# UNITED STATES PATENT AND TRADEMARK OFFICE

APPLICATION NO.	FILING DATE	FIRST NAMED INVENTOR	ATTORNEY DOCKET NO.	CONFIRMATION NO.
10/542,611	07/18/2005	Kenichiro Shinoi	L9289.05161	7286
53989	7590	12/30/2008		
Dickinson Wright PLLC James E. Ledbetter, Esq. International Square 1875 Eye Street, N.W., Suite 1200 Washington, DC 20006			EXAMINER BOLOURCHIL, NADER	
			ART UNIT 2611	PAPER NUMBER
			MAIL DATE 12/30/2008	DELIVERY MODE PAPER

### Office Action Summary

## DETAILED ACTION

FIG.3

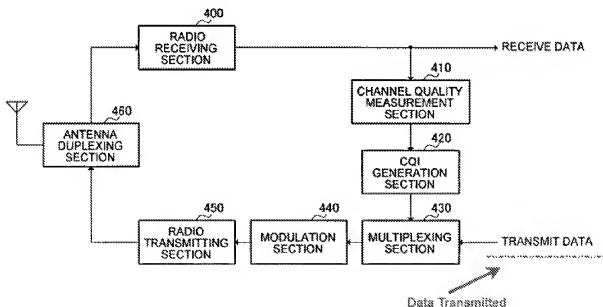
Claims 23 (lines 3-8) and 33 (lines 4-9) use the phrase "packet" which is vague and unclear. It is not clear what term "packet" is referring to.

Therefore, it should be equivalent to "transmit data" shown in Fig. 3 (emphasis added):

However, claims 23 (lines 3-8) and 33 (lines 4-9) use the phrase "packet" for data to refer only to "accuracy measurement data", which makes the term "packet" vague and indefinite.

FIG.2

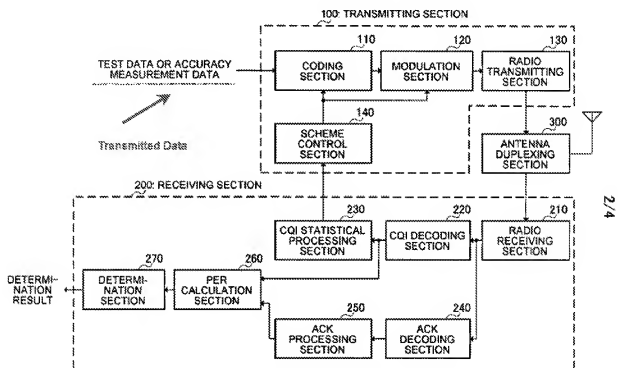
Furthermore, Fig. 2 clearly indicates that the data transmitted could be either "test data" or "accuracy measurement data", which as discussed above, one should concludes that "packet" is a data equivalent to either "test data" or "accuracy measurement data" (emphasis added)

Which is in contradiction with the specification disclosing that the data transmitted must be "test data and accuracy measurement data", which makes one to conclude that "packet" is a data equivalent to "test data and accuracy measurement data" (emphasis added)
